Santa Cruz/Alameda Corridor Safety Task Force

Pedestrian Safety Discussion- March 27, 2018

Santa Cruz “Y”

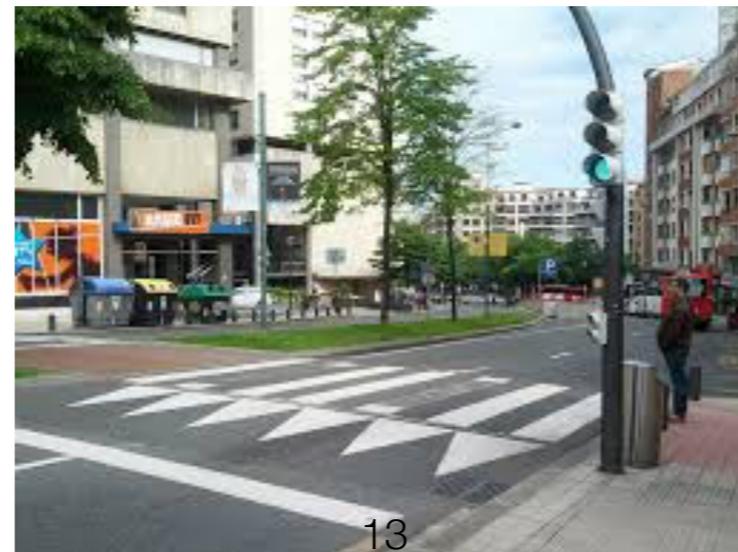
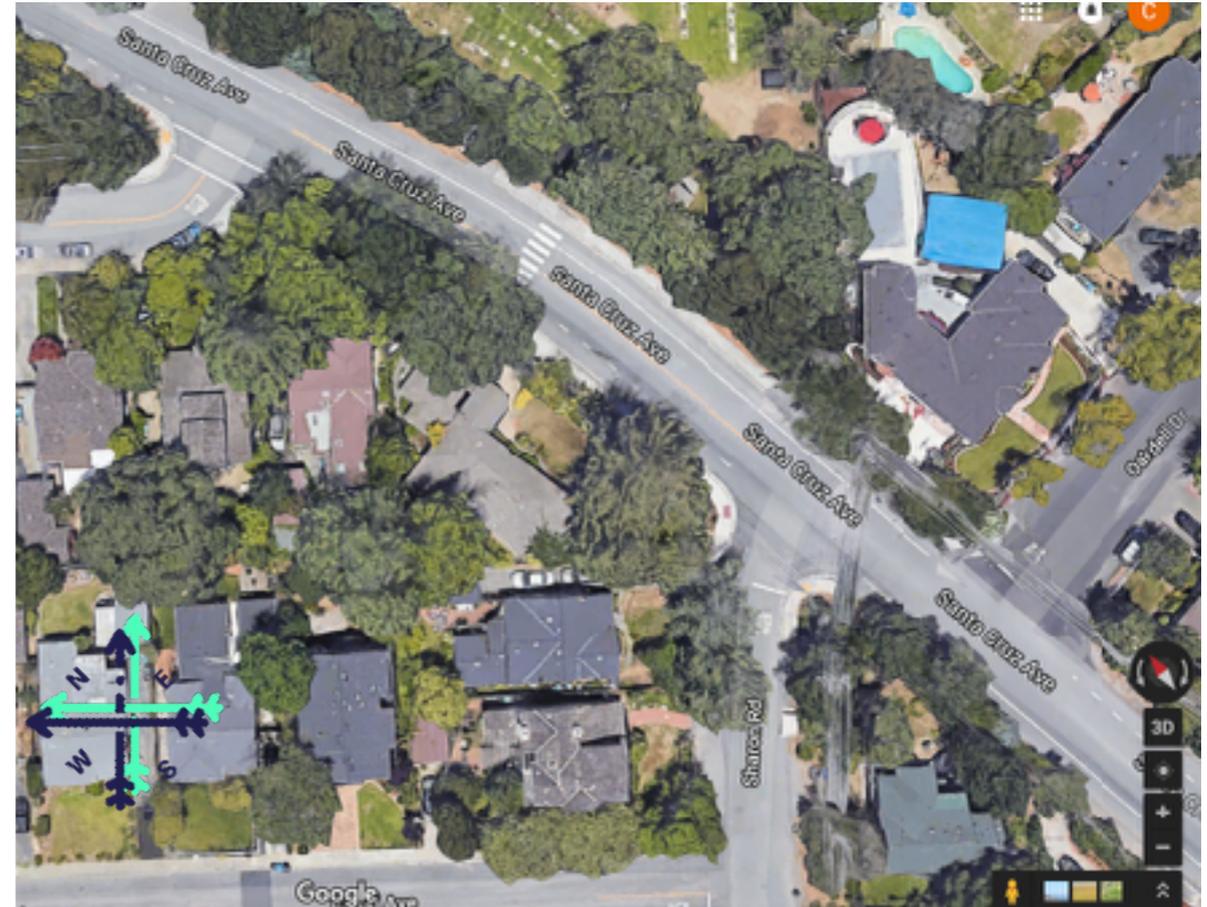
- **completion of northern cross walk here would allow the shortest distance for pedestrians to cross through traffic, much shorter than the current crossing distance at Campo Bello**
- **reposition angle of crosswalks to decrease distance across travel lanes**
- **removal of R turn-only lane from south bound SC to north bound Alameda would decrease crossing distance**
- **need pedestrian-activated lights and signage to stop single vehicle lane going N on Santa Cruz to allow pedestrians to cross**
- **increase center island size to provide safety zone**

Santa Cruz x Palo Alto Way

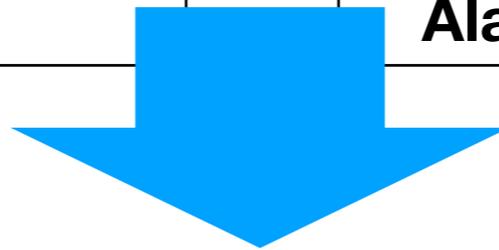
- High speed of motorists is a major issue
- long distance across 5 lanes increases chance of pedestrian-motorist collision
- recent stripping has enhanced visibility
- adding a pedestrian-activated light and/or other enhancements is a high priority
- Road diet would decrease crossing distance and speed of motorists
- Road diet merging immediately south of crossing may worsen pedestrian safety
